Clause 137 Channel Insertion Loss

Ali Ghiasi
Ghiasi Quantum LLC

IEEE 802.3bs Task Force Meeting

Nov 7th, 2016

Clause 137 Channel Response

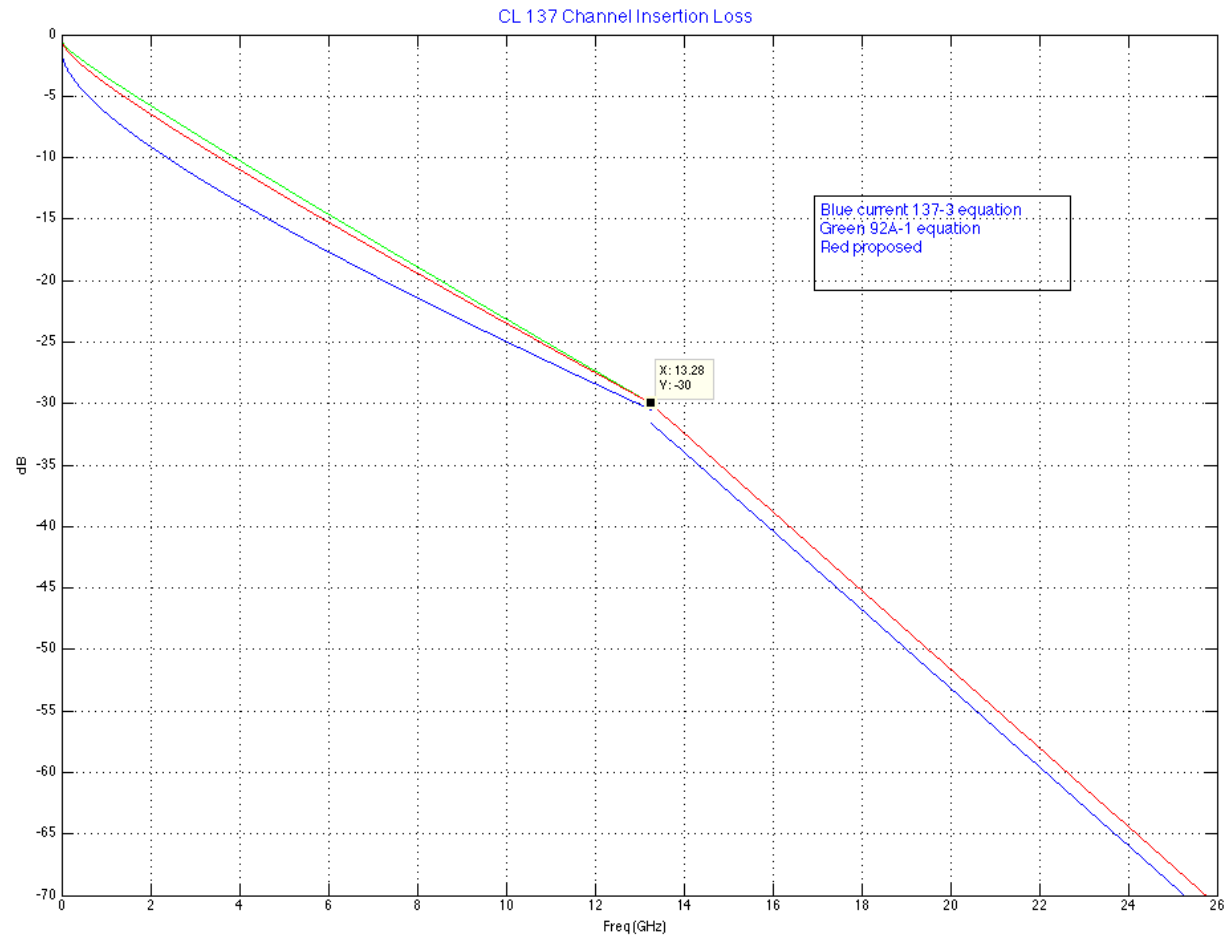
- ❑ **Current clause 137 PMD sublayer for type 50GBASE-KR, 100GBASE-KR2, and 200GBASE-KR4 has very strong \sqrt{f} response**
 - The recommended channel response has 750% stronger \sqrt{f} than clause 92A
- ❑ **To better fit material lower loss than Megtron 6 should increase \sqrt{f} coefficient of clause 92 A but there is no reason to increase the coefficient by 7.5x**
- ❑ **In support of comment 122 which proposes to increase the \sqrt{f} coefficient by ~2.2x compare to CL92A.**

□ In comparisons to clause 92A and proposed response

$$IL_{PCB} \leq \begin{cases} 0.4842 + 1.744\sqrt{f} + 1.744 \times f & \text{for } 0.01 \leq f \leq fb \\ -12.44 + 3.2 \times f & \text{for } fb \leq f \leq fb \end{cases} \text{ (dB)}$$
